Access Compliance Report

Public Rights-of-Way

(Curb Ramps)

Intersection ID: 12681	Main Street: PALOVERDE_LN	Cross Street: PENCE_RD	Location: NW
ADA ID: E0D10EBC537C	Ramp Type: Perp	Initial Pass/Fail: Fail	Overall Compliance: No
		Severity Score: 10

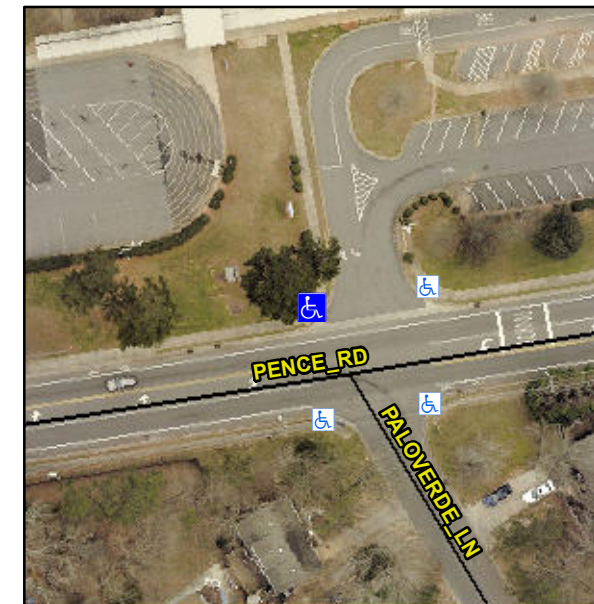
Not Found, R304.5.1

Compliance	Description	Data	Compliance	Description	Data
N/A	Ramp Length (in)	83.5	Yes	Ramp Slope (%)	6.8
No	Ramp Width (in)	40.0	Yes	Ramp XSlope (%)	2.8
N/A	Flare Type LT	N/A	N/A	Flare Type RT	N/A
N/A	Flare Slope LT (%)	N/A	N/A	Flare Slope RT (%)	N/A
N/A	Flare Traversable LT?	N/A	N/A	Flare Traversable RT?	N/A
N/A	Landing Length (in)	N/A	N/A	DWS Provided?	N/A
N/A	Landing Width (in)	N/A	N/A	DWS Contrast?	N/A
N/A	Landing Slope (%)	N/A	N/A	DWS Length (in)	N/A
N/A	Landing X Slope (%)	N/A	N/A	DWS Full Width?	N/A
N/A	Landing Curb? (Y/N)	N/A	N/A	DWS Offset (in)	N/A
N/A	Shared Landing?	N/A			
N/A	Gutter Ponding?	N/A	N/A	Gutter Slope (%)	N/A
N/A	Gutter Lip Ht (in)	N/A	N/A	Gutter X Slope (%)	N/A
N/A	Painted X Walk1?	No	N/A	Painted X Walk2?	N/A
	X Walk 1 Direction	To S		X Walk 2 Direction	N/A
N/A	X Walk 1 Width (in)	N/A	N/A	X Walk 2 Width (in)	N/A
	X Walk 1 Slope (%)	1.4		X Walk 2 Slope (%)	N/A
	X Walk 1 X Slope (%)	3.8		X Walk 2 X Slope (%)	N/A

Remove & Replace Entire Ramp.
